#### **CODE ANALYSIS**

# 15 West Street Proposed Residential Board and Care Portland, ME

Jacob Gelles

June 8, 2017

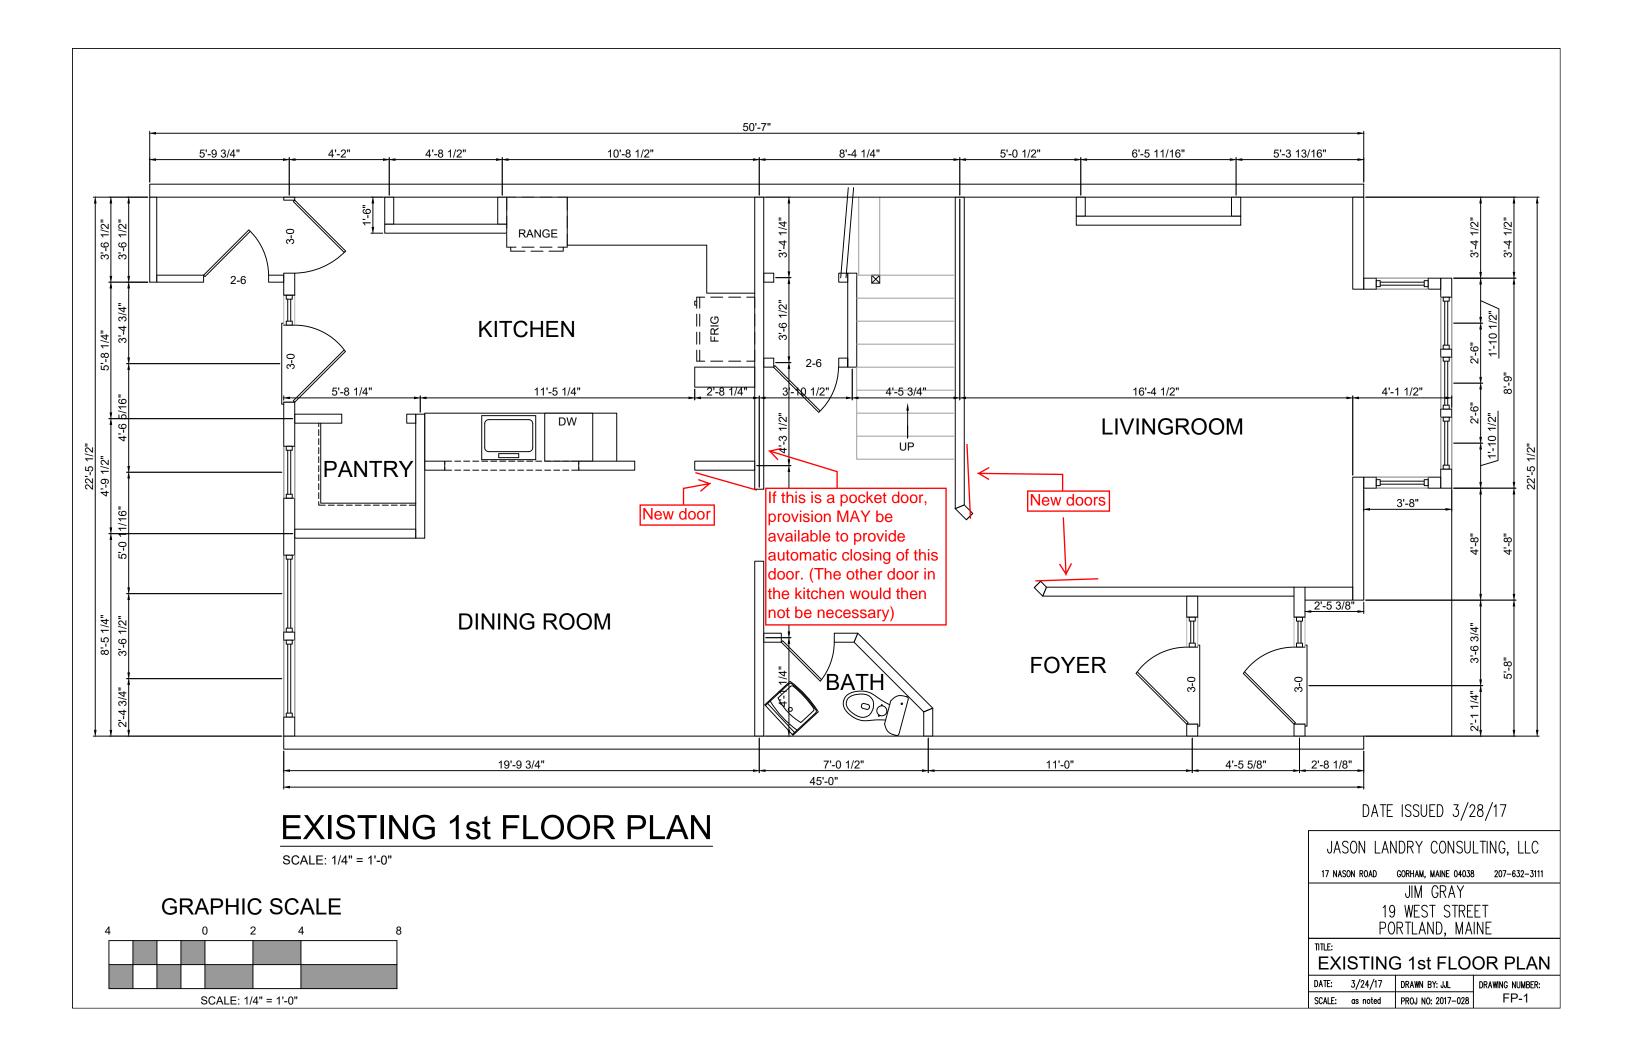
Due to the configuration of the first floor of the subject property, additional automatic closing doors would need to be added at the entrance to the living room and to the dining room, as shown on the attached floor plans (in red). One additional door may be required for floor two (if provisions for automatically closing the existing pocket door are not applied).
